## Product Change Notification / LIAL-04DQNT801

eSign# E000173629 Final notice: Released of updated Libero SoC v2022.3 for selected products in the PolarFire FPGA device family, including MPFxxx and RTPF device families.

# Subject: PolarFire® FPGA and SoC PORDIGEST and Tamper IP Update

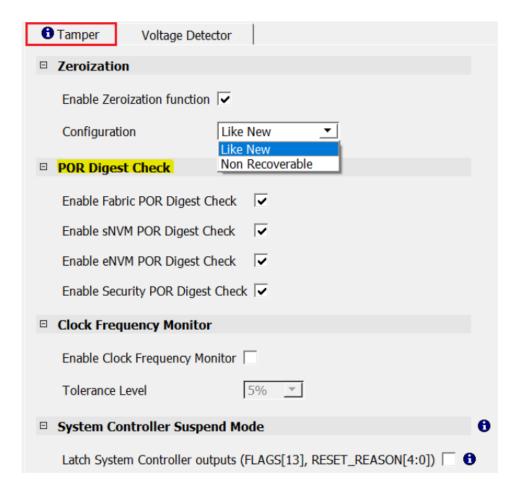
Designs using bitstreams generated prior to Libero SoC v2022.3, where the Tamper IP core is instantiated and configured to enable Power-On Reset digest checks on device components that were *not* included in the

programming bitstream, will see the Power-On Reset digest check fail. The Power-On Reset digest check failure causes the assertion of the corresponding Tamper IP core flag output. Although this Power-On Reset digest check failure is a false failure, the user design response to the tamper flag assertion determines the impact to the application.

The figure below shows the Tamper IP core configured with the Power-On Reset Digest Check enabled for all device components:

Important: Enable eNVM POR Digest Check is only applicable for the PolarFire SoC FPGA.

Upgrade to Libero SoC v2022.3, or later. Upgrade to the latest PF\_TAMPER (v1.0.212 or later) or PFSOC\_TAMPER (v2.0.100 or later) IP core, if used in the design. Then re-run the design flow, including the programming file generation and exports steps: Generate Bitstream, Export Bitstream, Export FlashPro Express Job and Export Job Manager Data.

Open the pre-2022.3 design in Libero SoC v2022.3. Notice that the following design flow steps will be invalidated: Generate Bitstream, Export Bitstream, Export Flashpro Express Job and Export Job Manager Data. Re-run the invalidated programming bitstream generation and export steps, then reprogram the device using the updated programming file. Updating the Tamper IP core version is not required if the core configuration is unchanged. If updates to the Tamper IP core configuration are desired, a Tamper core version update will be required as listed in section 2 of the Libero SoC v2022.3 Software Release Notes.
